Product/Process Change Notice (PCN)

PCN #: WE_LAN_20160119
Product Affected: 749020011A & 749023010A
PCN Date: January 19th 2015
Effective Date: April 18th 2015

DETAIL OF CHANGE:

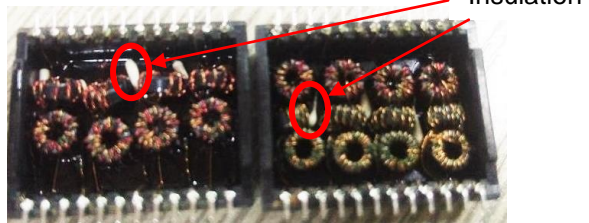
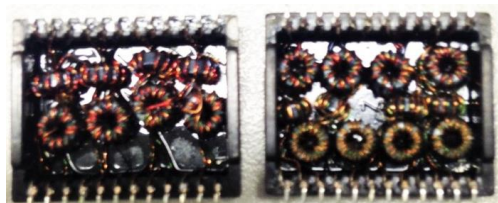
In order to enhance the product reliability, Würth Elektronik will add insulation layer for the twisted wires to avoid possible short circuits between the uninsulated wires and the customers PCB. There will be no change in form, fit, function or quality.
